Technical Service BULLETIN

MULTI-DISPLAY FUNCTIONS ARE INOPERATIVE

'04 Highlander, Land Cruiser & Prius

ELECTRICAL
EL002-05

Highlander M3 Wiring Harness Side Connector

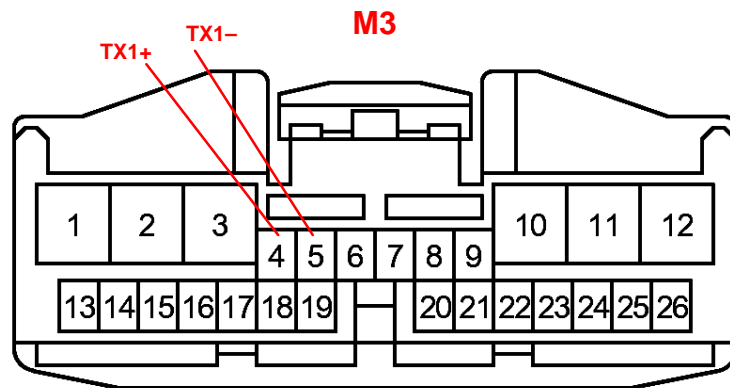
1. Check all the TX terminals on the multi-display connectors (please see connector diagrams) and confirm the terminals are fully seated. Replace any damaged terminals or connectors.
2. Confirm the connectors to the multi-display are fully seated. Replace any damaged connectors.
3. If all the TX terminals are tight and the connectors are fully seated, replace the multi-display.
